**Exhibit A**

**File No. 230626**

**1<sup>st</sup> Amendment to Detailed Planned Development known as Block 3 – Arena Master Plan (Phase 1)  
1051 & 1047 N Vel R Phillips & 500 West State Street (formerly part of 1001 N. Vel R. Phillips Av.)  
September 18, 2023**

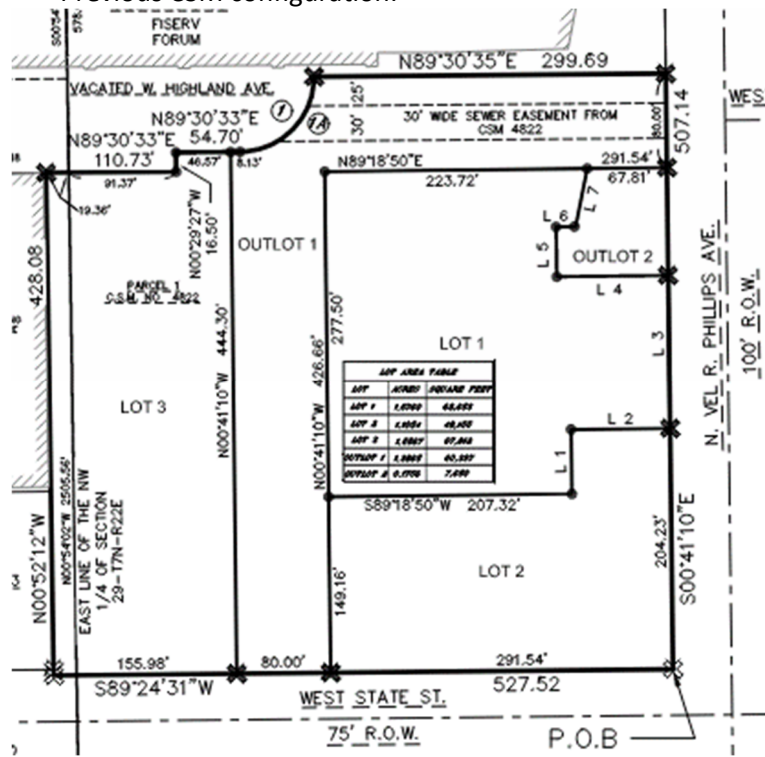
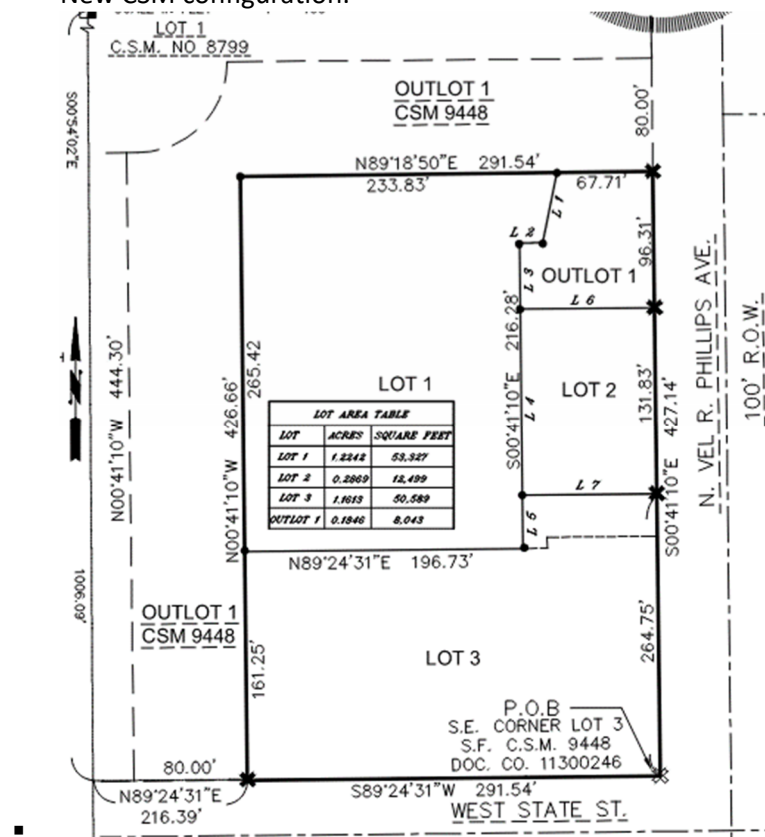
- A new CSM has been submitted to split the Lot 1 (1051 N Vel R Phillips) parcel and create a new lot (to be known as Lot 2) between the music venue and Vel R. Phillips Avenue for future development.

- The music venue parcel (1051 N Vel R Phillips) will continue to be known as Lot 1 of the CSM, and the Outlot (1047 N Vel R Phillips) northeast corner plaza of the site will now be known as Outlot 1.

- Because of the smaller footprint of the music venue, approximately 2,434 square feet of land within the DPD is no longer needed and will be shifted to the south parcel 430 West State Street (Lot 3), which is zoned General Planned Development (GPD; Arena Master Plan).

- The new CSM submitted, in conjunction with this amendment request, created a need to clarify the Lot and Outlot names and addresses as follows for this amendment:

- Lot 1 - 1051 N Vel R Phillips remains as the music venue parcel; remains in the DPD. Approx. 2,434 sf of land from this lot will shift to Lot 3
    - Lot 3 - 430 West State Street (formerly Lot 2) – remains zoned GPD and gets slightly larger

- Lot 2 (future development site)– Requires new address to be assigned (formerly the east portion of Lot 1); remains in DPD
    - Service/Plaza Outlot - 500 West State Street (service drive and north plaza that were formerly labeled as Outlot 1 in the original CSM and DPD exhibits); remains in DPD

- Outlot 1 (east plaza) - 1047 N Vel R Phillips (formerly labeled as Outlot 2 in the original CSM and DPD exhibits); remains in DPD
